SPECIAL CITY COUNCIL MEETING
Tuesday, July 31, 2012 7:00 p.m.
Community Recreation Center
10640 N Clubhouse Drive, Cedar Hills, Utah

SUBJECT:	Bridgestone Plat C Final Approval
APPLICANT PRESENTATION:	Brandon Dyer
STAFF PRESENTATION:	Greg Robinson, City Planner

Perry Homes has submitted final development plans for Bridgestone Plat C. The new plan does not change the density of the development; however it does include two 8-plex units. All of the units currently located in this HOA are 4-plex units and full brick with upgraded roofing materials. The HOA has expressed their interest and support of the Perry Homes development and have attended several meetings.

FRONT ELEVATION
 BUILDING B

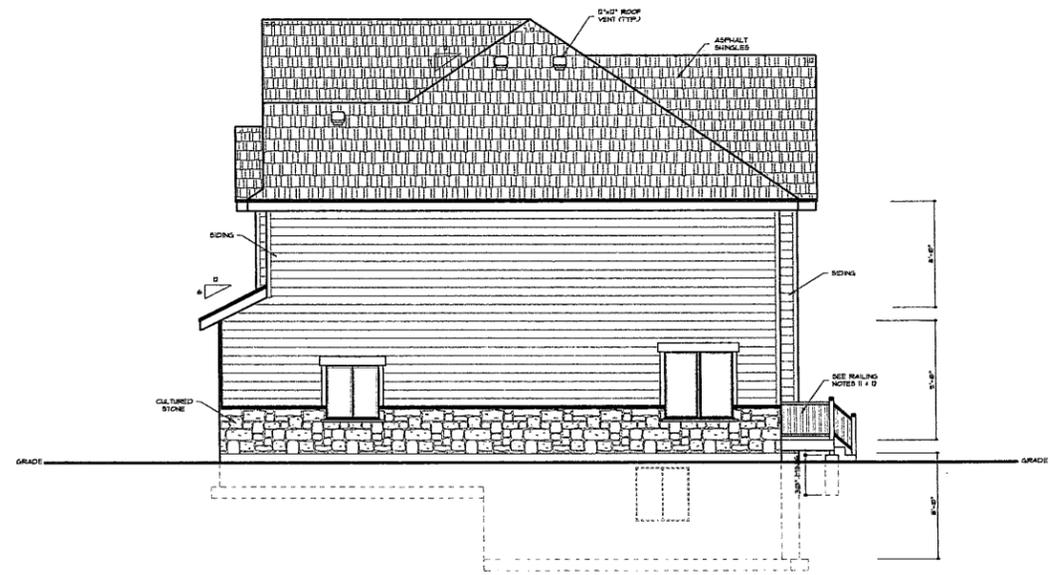
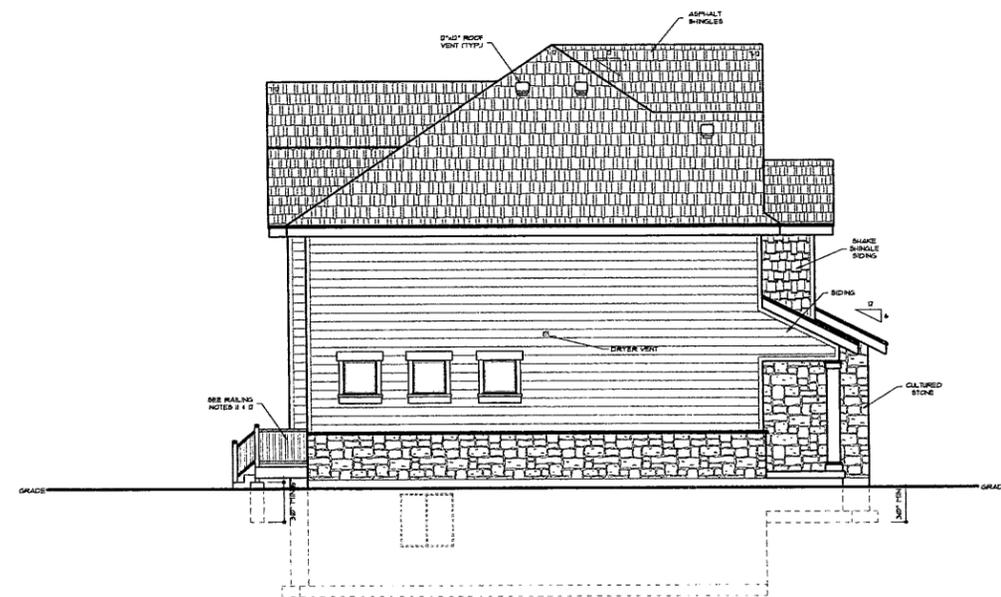
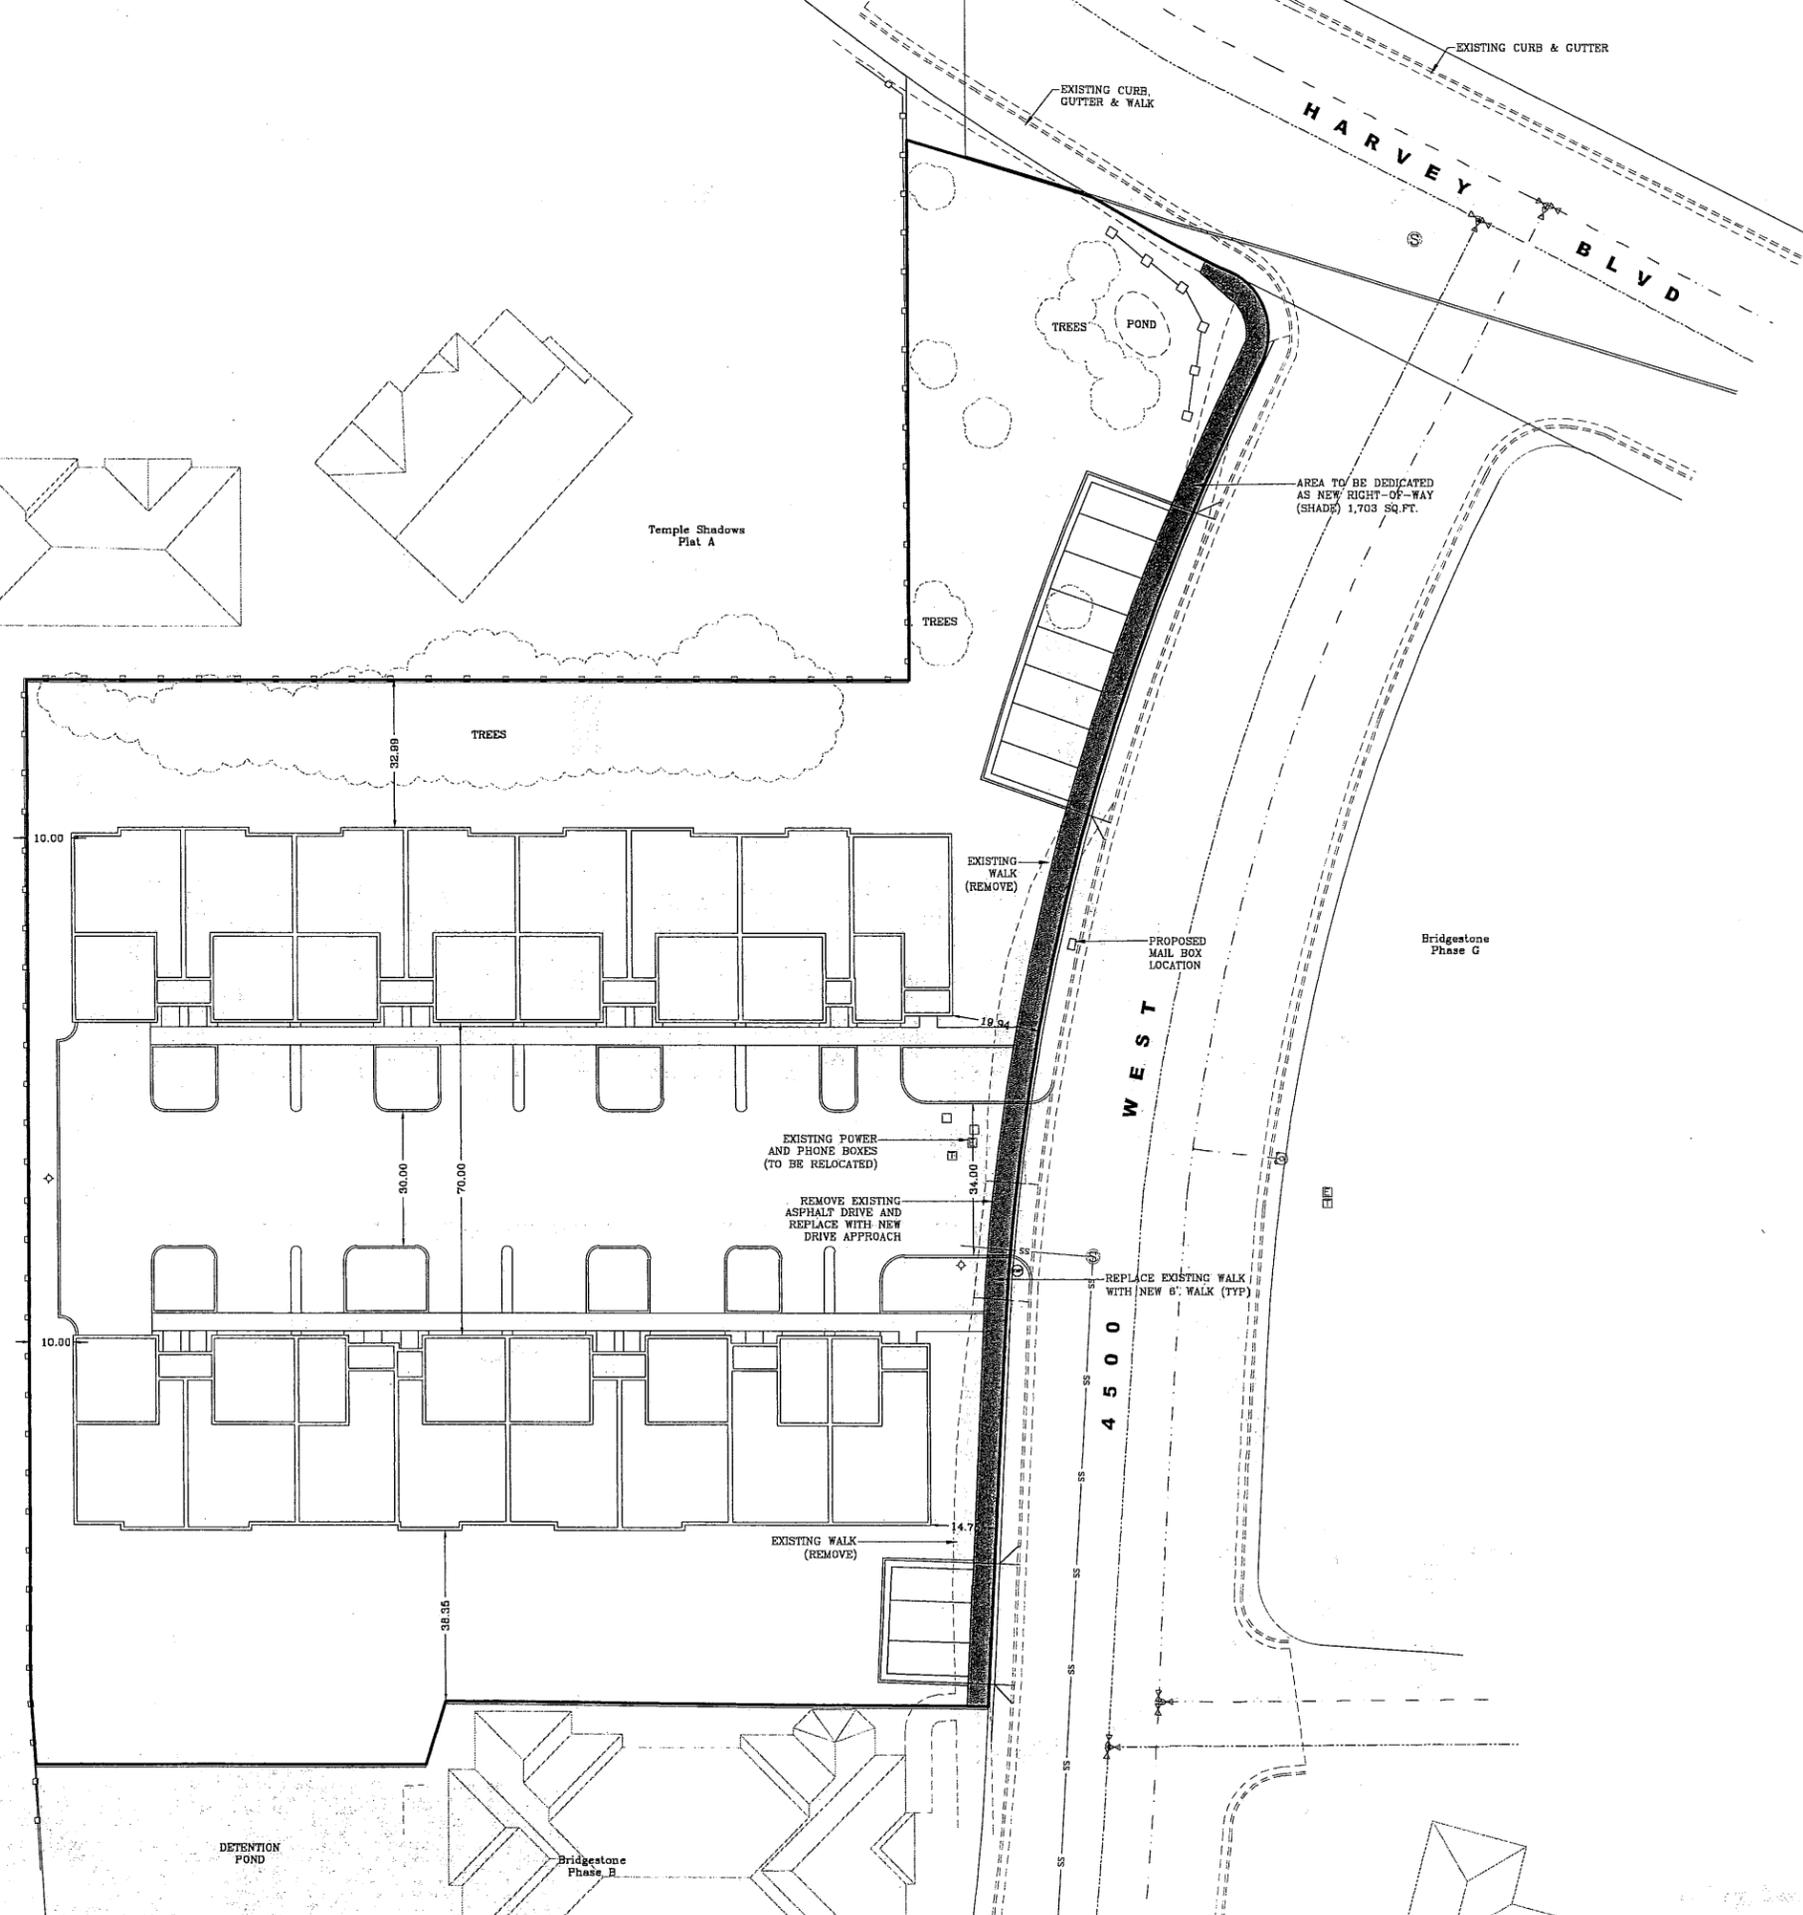
Exterior materials, adding more brick. Definitely need some sections in the back that have brick all the way up. Maybe a percentage requirement for brick.

The side of the house facing 4500 W should have more brick to match what is in the neighborhood since it is going to be right in your face, and should have a broken up façade to avoid a big blank wall.

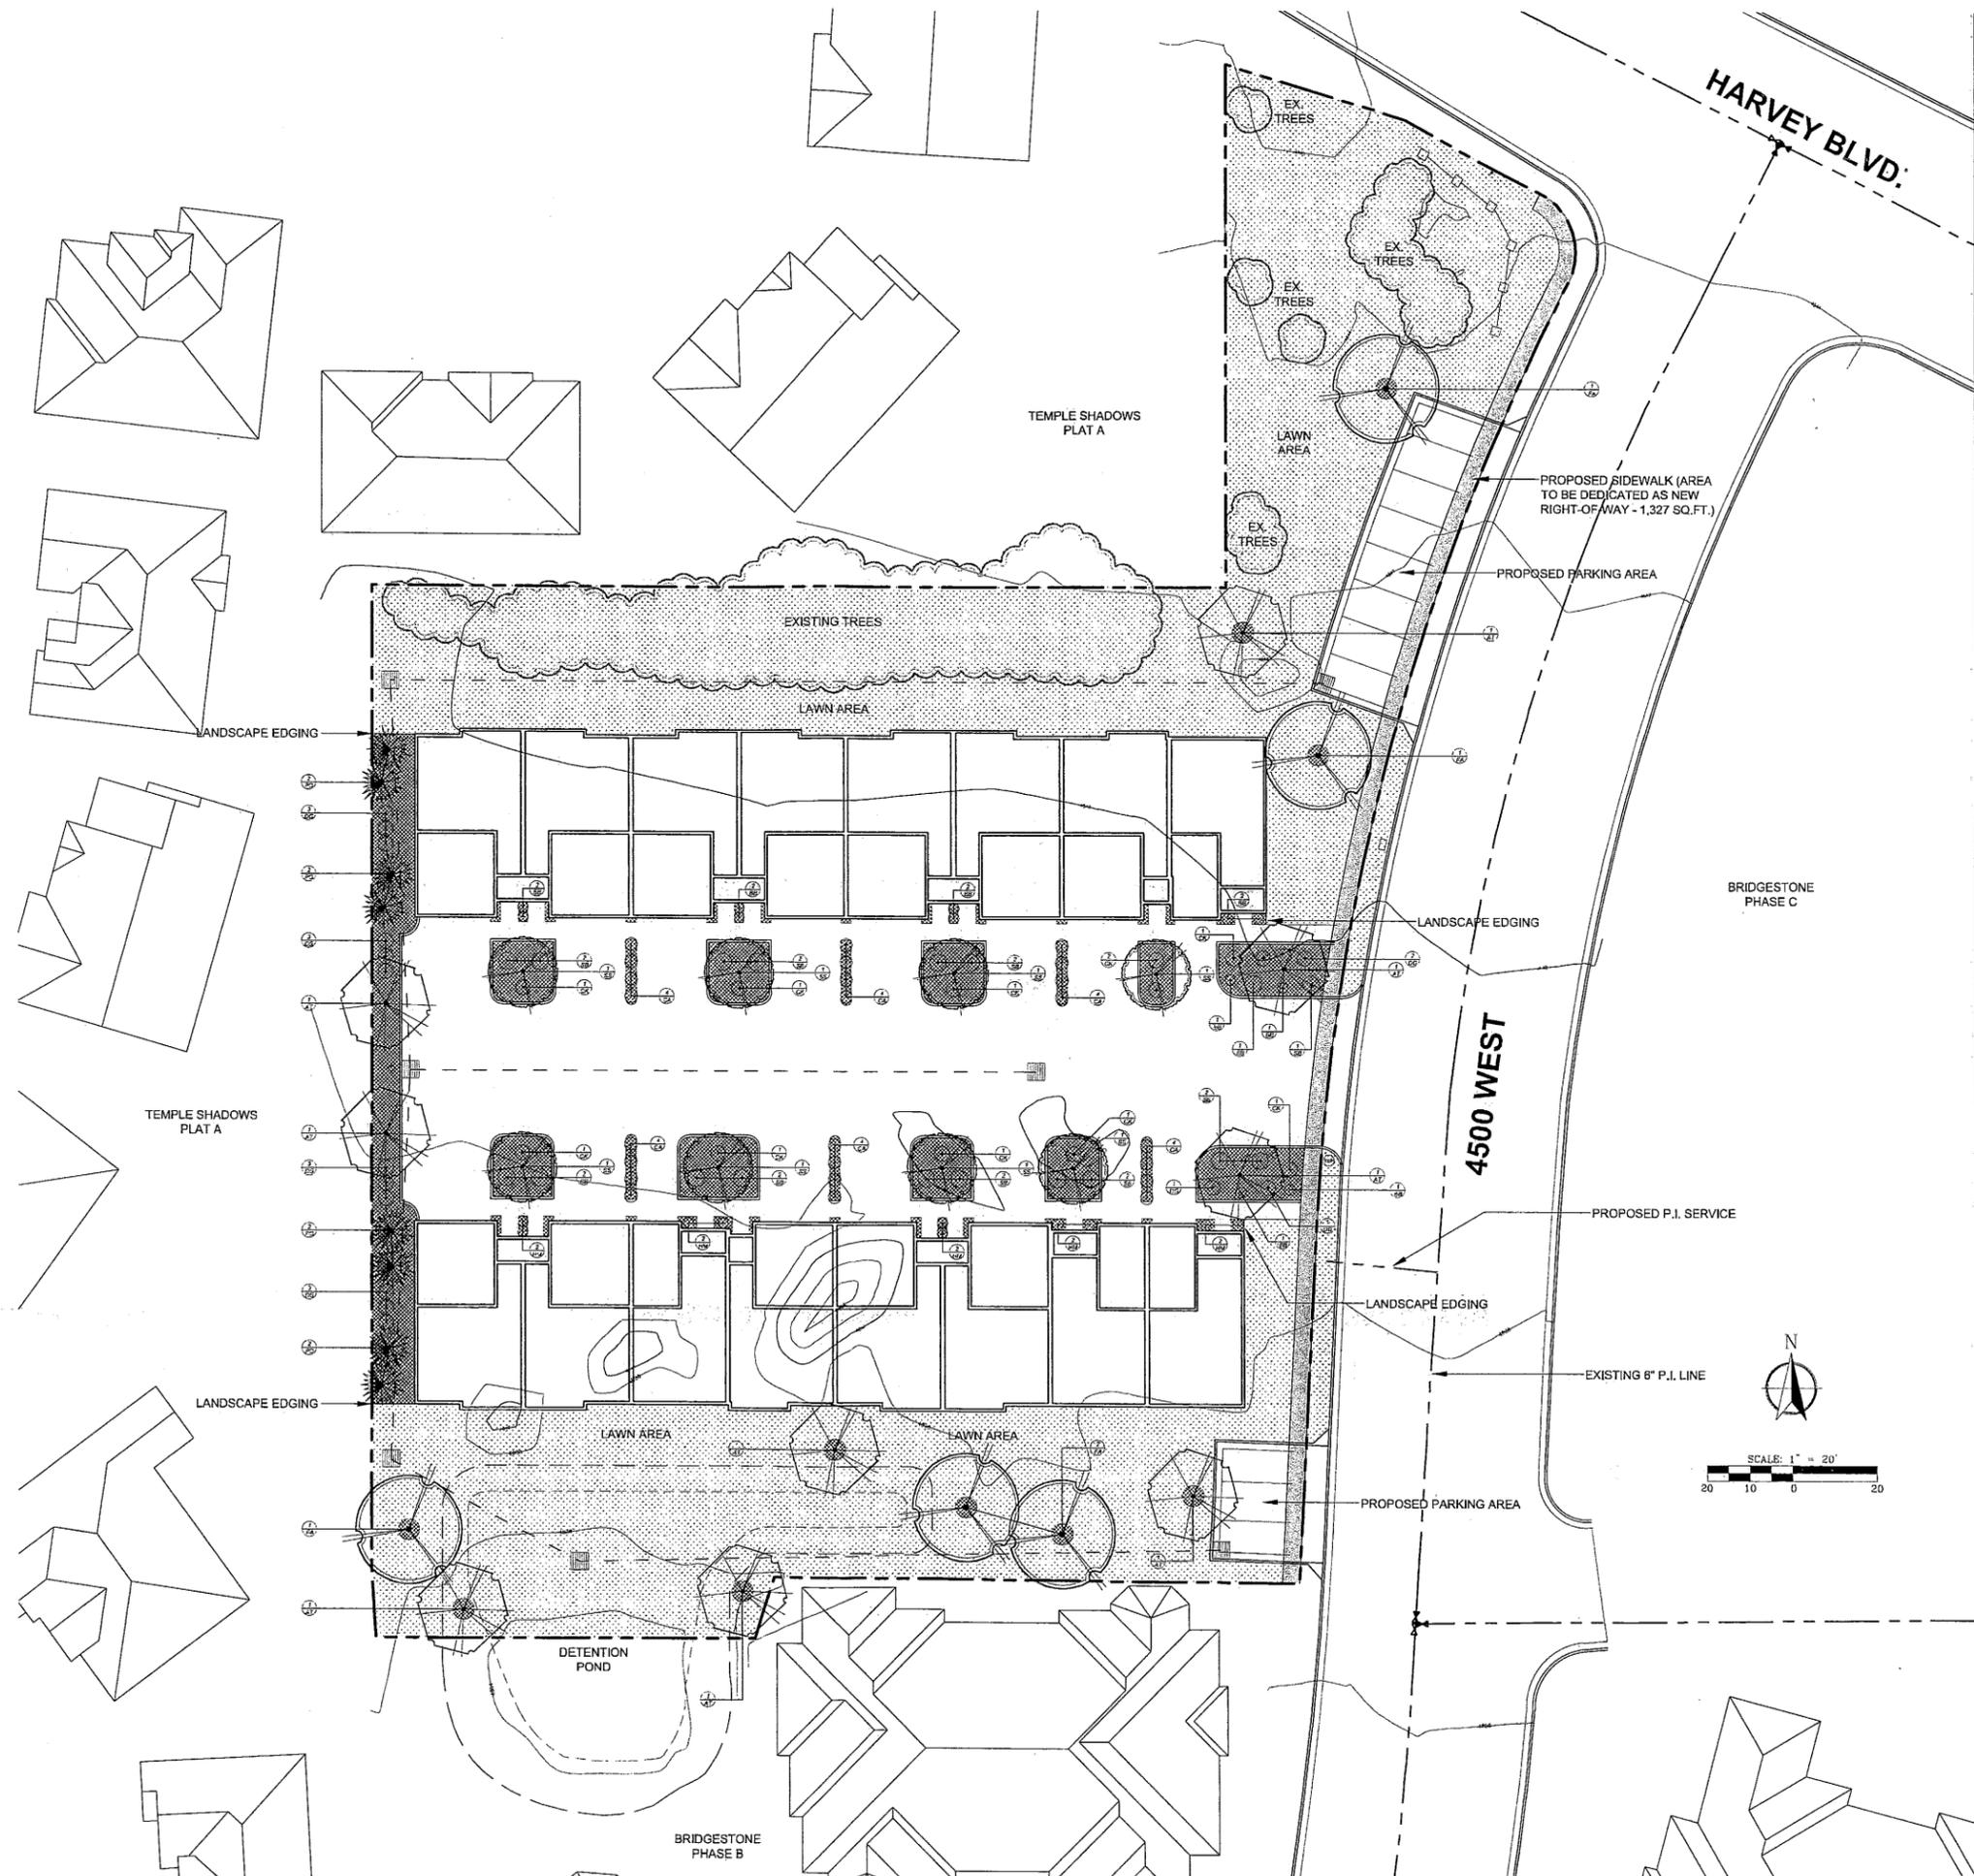
Replace the apple trees:

More evergreens for screening the back of the buildings
